### Carolina Estates Replat A

City of El Paso — City Plan Commission — 6/14/2018

SUSU17-00040 — Resubdivision Combination

### EXISTING CAROLINA DRIVE CROSS SECTION

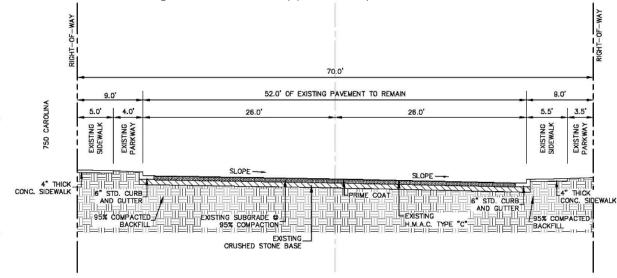
The applicant proposes to preserve the existing configuration of Carolina Drive, which includes a 5' sidewalk, 4' parkway and 26' of pavement. As such, the applicant is requesting to waive 1' of parkway and 3' of roadway as required per the DSC. The linear street frontage the proposed subdivision will have along Carolina Drive is approximately 177 feet.

Currently, the applicant has the proper configuration of the improvements. The roadway is consistent throughout Carolina within a quarter mile; however, the parkway varies throughout as certain parcels have the sidewalk and no parkway or vice versa.

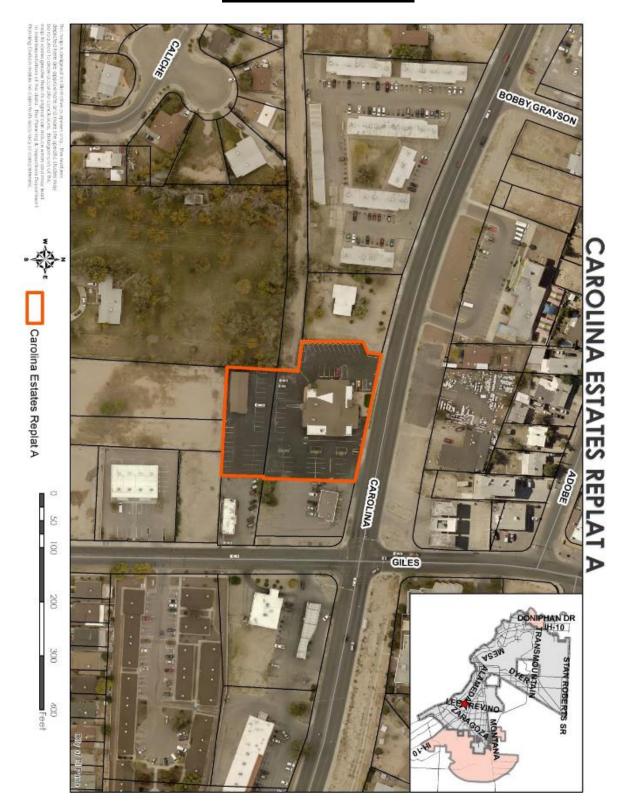
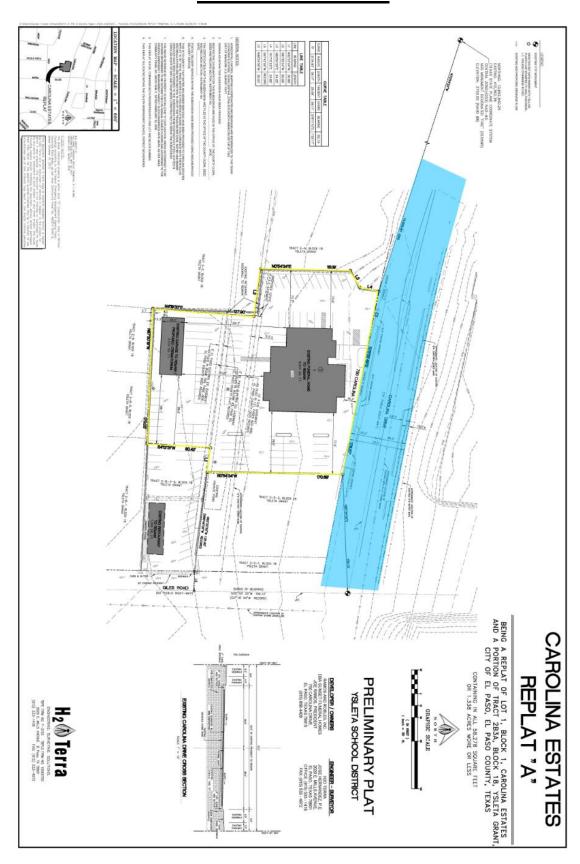
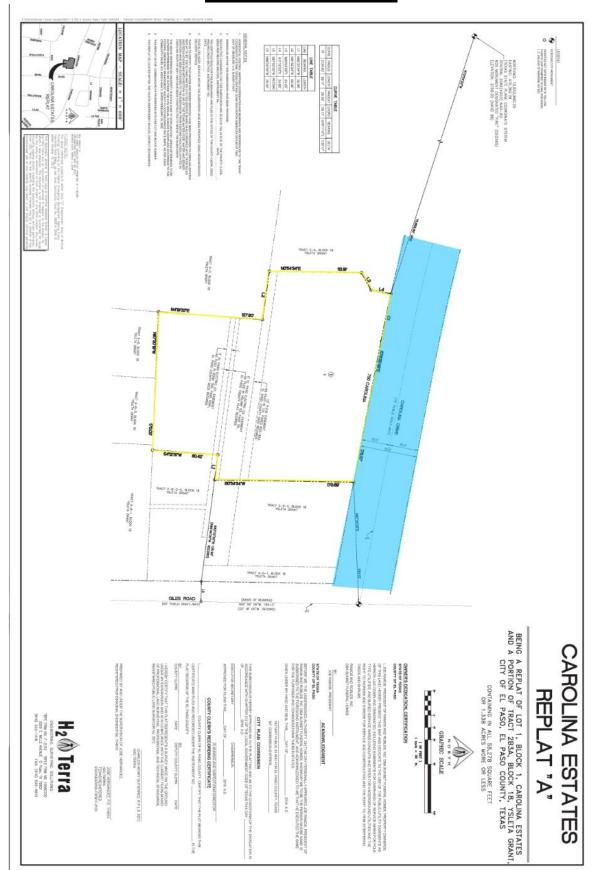
- 1. Show existing and proposed drainage flow patterns on the preliminary plat. Identify the discharge location for all storm-water runoff.
- 2. Need to show the storm sewer lines along Carolina Dr. in front of the property.
- 3. Dimensions driveway widths.
- 4. Add FEMA flood zone information to general notes on both preliminary and final plats.
